PARISH OF ASCENSION
OFFICE OF PLANNING AND DEVELOPMENT
PLANNING DEPARTMENT

Planning Commission

October 12, 2016 - 6:00 PM
Courthouse East, 2nd Floor, Council Meeting Room
Gonzales, Louisiana

AGENDA

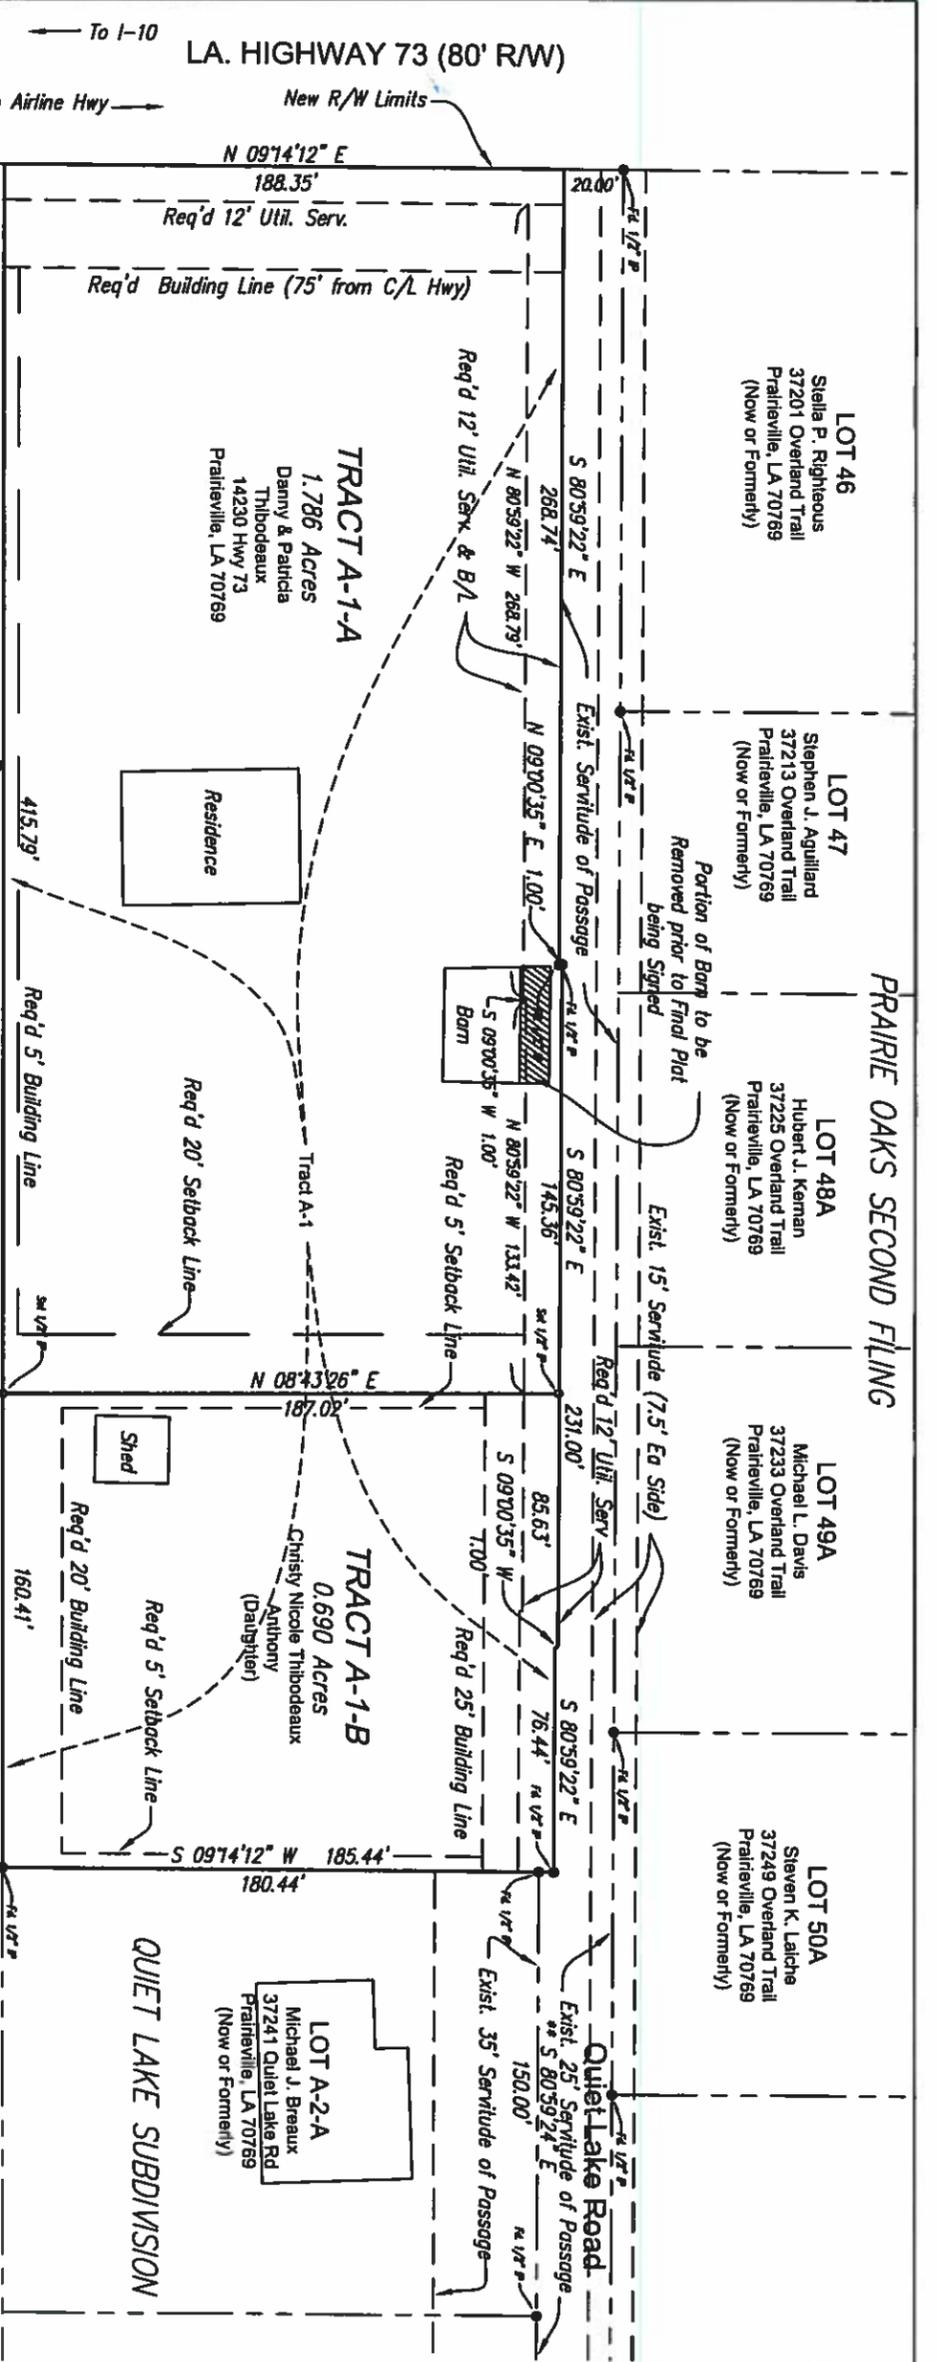
STAFF REVIEW COMMENTS

All items as per ordinance have been addressed on the plat along with the required notes, labels, setbacks and servitudes as per Paragraph 17-406 of the Subdivision Regulations.

To remove the conflict, a portion of the existing barn must be removed from the proposed 12' utility servitude as noted on the map prior to the final plat being signed.

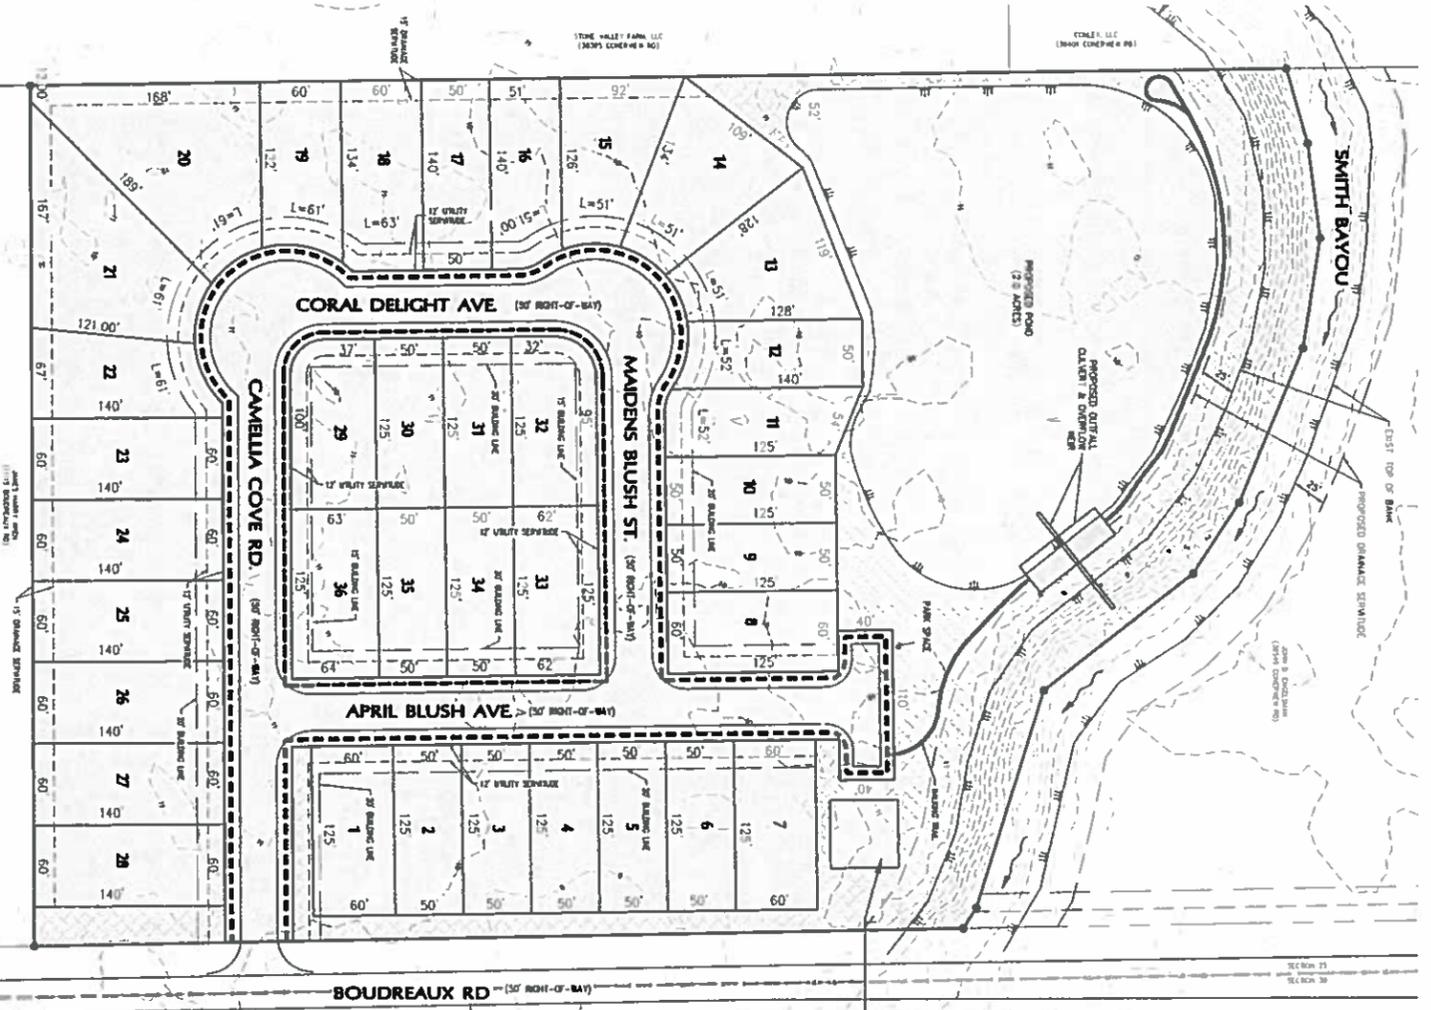
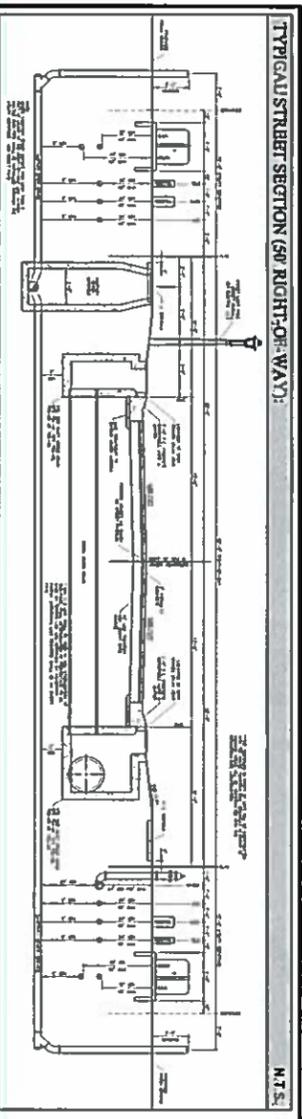
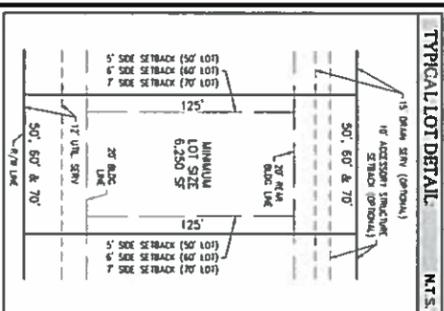
1. Depict all proposed rear-yard swales and servitudes per Section 17-4044H. **This has been updated on the plat.**
2. Show any existing drainage servitudes for the bayou. **This has been updated on the plat.**

3. Show proposed drainage servitudes for the bayou in accordance with Section 17-4045E. **This has been updated on the plat.**
4. Depict the proposed pond outfall location. **This has been updated on the plat.**

6. Depict the proposed driveway connection to Boudreaux Road. **This has been updated on the plat.**
7. Show any pre-existing drives. **This has been updated on the plat.**

8. Depict the location of the entrance to Bayou View Estates Subdivision on Boudreaux Road. **This has been updated on the plat.**
9. Label Smith Bayou and show flow direction arrows. **This has been updated on the plat.**

12. Add a note stating: "Lots 1 – 7 and Lot 28 shall not have direct access connection to Boudreaux Road." **This has been updated on the plat.**
13. Google Earth suggests there may be an existing drive on the north-eastern corner of the property connecting to Boudreaux Rd. This should be depicted on the plat if it still exists. **There is no existing drive on the north-eastern corner of the property.**
14. Pumping sanitary sewer (aka "cascading") to an offsite private treatment plant is not allowed. Show proposed location of treatment plant. Please make the necessary changes to your preliminary plat to show a treatment plant or pumping to an Ascension Parish owned treatment plant. **Consultant has revised to show a proposed treatment plant.**

1. Include adjacent property owner's addresses on plat. **This has been updated on the plat.**
2. Show location of proposed pump station or STP should cascading prove impossible. **This has been updated on the plat.**

3. Include inundation of 10.1' as discussed in pre-application meeting. **This has been updated on the plat.**
4. Lots 11, 12, 29 and 32 do not meet minimum square foot sizes according to the ordinance. Please revise or request a variance on the lot sizes. **The layout has been revised to accommodate the required lot sizes.**

5. Per drainage ordinance 17-505A4, the lowest gutter elevation of all proposed public and private roadways cannot be lower than record inundation. The Planning Department should be contacted to determine if the August 2016 flood established a new record inundation for this site. **Consultant responded, "We will be sure to get with the parish during the construction plan phase and determine the minimum road elevation."**

1. Because there are areas on this site below BFE, provide preliminary estimates for how much flood plain volume this site provides, how much storage is taken away from the proposed fill, how much additional storage will be generated, and note the proposed method for storage creation. **Consultant has provided.**

2. Provide a cross-section showing the grading of Smith Bayou and both sides of the proposed pond to better understand the intent of the pond design relative to the existing bayou. **Consultant has provided.**

3. Per section 17-4044H, rear yard swales are required for all lots unless a natural ridge exists. The post developed drainage map suggests a ridge lies exactly on the southern property line and thus allows zero water to enter the site from the south. Provide the information (e.g. ditches, topography, etc.) available to make this determination. **Consultant has provided.**

4. Depict existing contours on the proposed drainage layout. **Consultant has provided.**
5. The models for Reach 1: Smith Bayou give average flow depths, but do not provide an elevation to correlate this with. Knowing this information is imperative because it could impact the design depths for the entirety of the site. Therefore, all existing and proposed input values of the HydroCAD models should be provided. **Consultant has provided.**

1. The traffic study only accounts for 34 lots, whereas the plat includes 36 total lots. The traffic study should be revised to reflect this increase. **Consultant provided updated study.**

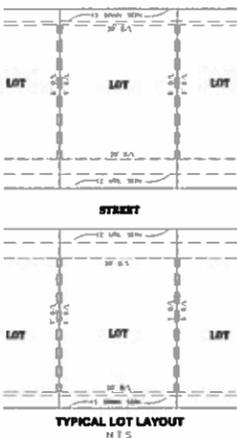
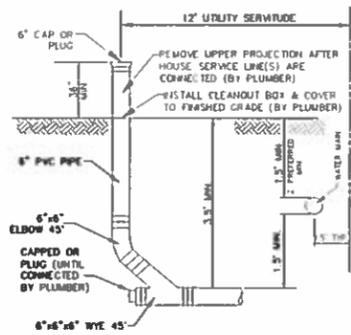
1. Since this is a private subdivision, Section 17-4024 requires that the subdivisions restrictions must be approved by planning commission and recorded prior to acceptance of final plat. These restrictions need to address to accommodations for school buses, emergency vehicles, public utilities access, and street maintenance. Add note to preliminary plat stating that "Subdivision restrictions must be reviewed and approved by planning commission and recorded prior to acceptance of final plat." **Consultant has provided**

2. Remove the note stating, "Any new drainage ditch required by the subdivision of this property for the purpose of transporting runoff or sewage treatment plant effluent to an existing parish maintained ditch shall be constructed and maintained by the property owners." This project is not proposing a ditch to convey sanitary sewer. **Consultant addressed this comment.**

1. Add a note stating, "This project is subject to development fees and traffic impact fees in accordance with the Ascension Parish ordinances. **Consultant has provided.**

2. The waiver request ("Section 17-4038 for block length for west side of Oakbourne Ave") does not fall under the proper ordinance section and should be updated to reflect the correct section. **Consultant has provided.**

3. Show the location and configuration of the proposed access gate. **Consultant has provided.**
4. The existing ditch is difficult to see as depicted and should be darkened or otherwise depicted more clearly. **Consultant addressed this comment.**

5. Note the flow direction of the existing ditch. **Consultant addressed this comment.**

6. Label the existing and rerouted portions of the ditch separately. **Consultant addressed this comment.**
7. Provide all greenspace landscaping details (e.g. tree and park space standards) as required per ordinance and denote upland park acreage. **Consultant addressed this comment.**

8. Depict all proposed pedestrian systems including sidewalks, walking paths, and trails in order to verify connectivity to greenspace. **Consultant addressed this comment.**

9. Depict the proposed pond outfall location. **Consultant has provided.**
10. Show line work to depict proposed roadway and medians. **Consultant has provided.**

11. Provide proposed cross-section of sidewalk details and any other pedestrian walkways. **Consultant has provided.**
12. Show all proposed drainage servitudes and widths in accordance with Section 17-4045E. **Consultant has provided.**

13. The side inlet drainage boxes on the typical section are to be precast instead of the currently depicted brick. **Consultant addressed this comment.**

14. Show the proposed sanitary sewer stacks with the typical street section. **Consultant has provided.**
15. Note the thickness of the asphalt and roadway base in the typical street section and ensure the specifications match the requirements for public roadways unless a variance is otherwise requested. **Consultant addressed this comment.**

16. Section 17-4044H states rear yard swales are required unless there exists a natural ridge or a variance is granted. In addition, all private drainage servitudes for swales should be noted. **Consultant addressed this comment.**

17. In order to ensure adequacy of the finished floor elevation, provide record inundation of the August 2016 flood. **Consultant will coordinate with the Parish to determine a record inundation for the project.**

18. State the proposed plan for all school buses picking up children. We recommend coordinating with the school board in order to have an acceptable plan in place. **Consultant responded, "The school bus pickup is planned to occur at the front entrance and use the turnaround outside of the front gate. We have been in contact with the Ascension Parish Board and will continue to refine the front entrance geometry in the construction planning phase."**

21. Provide a legend showing hatching designations for the shaded region and sidewalks. **Consultant has provided.**
22. Pumping sanitary sewer (aka "cascading") to an offsite private treatment plant is no longer allowed. Show proposed location of treatment plant. **Consultant responded, "This exact system design concept was approved by the Parish and Parish Attorney a few months ago in the spring of 2016 for the Grove at Ascension subdivision (Lift station onsite pumping to an offsite non-parish owned plant). We would like to know when these changes (new requirements) were made and if they were by ordinance. We also aren't sure why the Parish would want to create an additional discharge point when they are trying to consolidate the sewer systems. We have contacted the Parish with these inquiries and are awaiting input/response."**

3. Verify park space acreage is correct, consistent, and meets ordinance requirements. **Consultant has provided.**
4. Note the existing and proposed ditch widths at the front of the property. **Consultant has provided.**

5. Hatch or otherwise make the delineation between flood zones 'X' and 'A' more clear. **Consultant has provided.**
6. Since there are no plans to construct a street on lot GS-3, it should be stated that no obstructions of any kind will be placed on Lot GS-3. It should also be noted that if the streets in Oakbourne are ever made public, the roadway shall be paved to the rear of Lot GS-3 so that it may tie in to Oak Crossing Ave. **Consultant has provided.**

1. Separate all onsite areas from the pre developed and post developed hydrographs in order to ensure that the site does not increase post developed runoff when compared to pre developed conditions. There may be additional comments regarding CN values and time of concentration values after reviewing the drainage areas have been revised and resubmitted. **Consultant addressed this comment.**

2. According to the HEC-RAS model for the post-developed re-routed ditch, the top bank width will be about 30 ½ feet. Per section 17-4045-E, a minimum servitude width of twenty (20) feet must be provided on each side from the top banks of the ditch. The proposed preliminary plat only leaves about 7 ½ feet on the left side of the ditch, which is not sufficient for satisfying servitude width requirements. **Consultant revised plat to show necessary servitude width.**

3. Provide preliminary estimates for how much flood plain volume this site provides, how much is taken away from the proposed fill, how much additional storage will be generated, and note the proposed method for storage creation. **Consultant has provided.**

4. More in-field topographic surveying is needed during the construction planning phase in order to verify that onsite areas 10B and 10C are draining towards the rear wales of Lakes at Dutchtown Subdivision as indicated on the pre-developed watershed map. **Consultant acknowledged this requirement.**

5. The combined flow from the onsite areas draining to Outfall 20 is greater than the existing conditions. Therefore, additional detention is required for the proposed pond. **Consultant provided additional information to confirm that total flows are correct and that additional detention is not warranted.**

The block length waiver being requested on the west side of Oakbourne Ave. was discussed at the pre-application meeting and was requested due to the fact that this project is presented as a private subdivision, land use of the existing adjacent property to the west of the site and the unlikely possibility that a roadway would ever continue through to Hwy 928 (Bluff Road). A lot 'break' was proposed between lots 18 and 19 as Lot GS-3 to satisfy the ordinance. Staff required that notes be added to state that no obstructions would be placed on this lot and that, should the subdivision ever desire the streets go public, the HOA will provide the street connection to Oak Crossing Ave. on a roadway constructed to parish standards. Staff analysis is that this action satisfies the purpose of Table 'C'-Block Length of the Zoning Code.

Applicant is requesting a waiver on side setbacks from Table 'C' of the Zoning Code. The intent of table 'C' is to govern Major Subdivision Development and provide a variety of lot sizes and setback requirements for multiple product offerings within a subdivision. Table 'C' of the Zoning Code applies as the standard for Major Subdivisions and requires side setbacks according building classification and lot width. The typical 5' side setback for the RM classification of Zoning is to be applied for minor and individual lot

- Block length waiver is granted with stipulations on Lot GS-3 as noted.
- Waiver on side setbacks is denied. Should the denial of the setback requirements dictate a reduction in the number of lots, the revised plat can be approved at staff level.
